Z-33
(2012)

PETITION NO: Z-33

PROPOSED ZONING: HI

PROPOSED USE: Recycling Center

SITE PLAN FOR:
**SOLOMON
AJIBOGUN**
BEING LOT 7, BLOCK 1
J.R. COLE, JR. & LOY A. COLE PROPERTY
LOCATED IN LAND LOT 499 & 503
IN THE 18TH DISTRICT, 2ND SECTION
COBB COUNTY, GEORGIA
SCALE: 1" = 50' DATE: MARCH 27, 2012

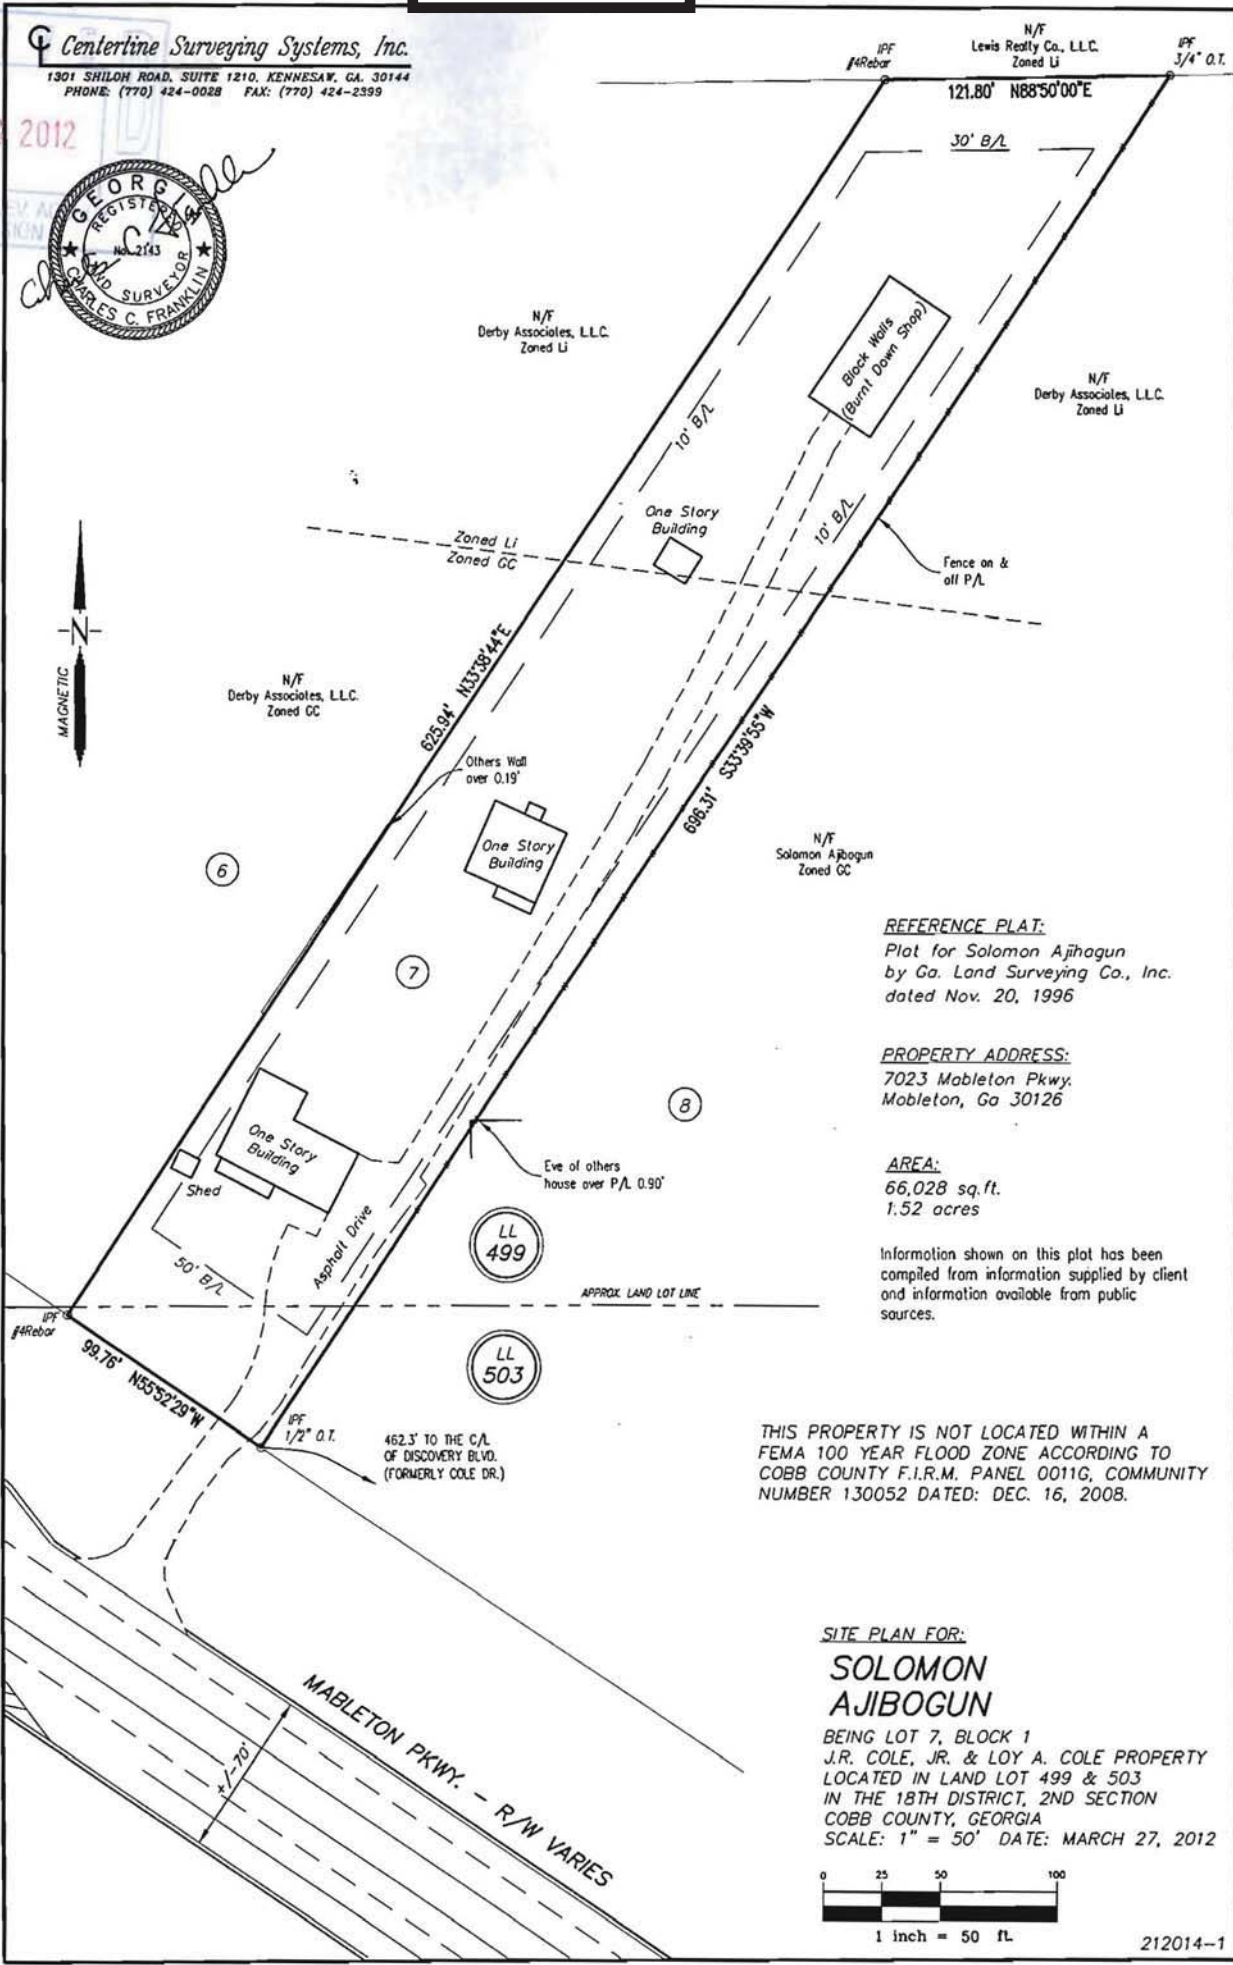
- No Stormwater controls shown _____
- Copy of survey is not current – Additional comments may be forthcoming when current site conditions are exposed.
- No site improvements showing on exhibit.
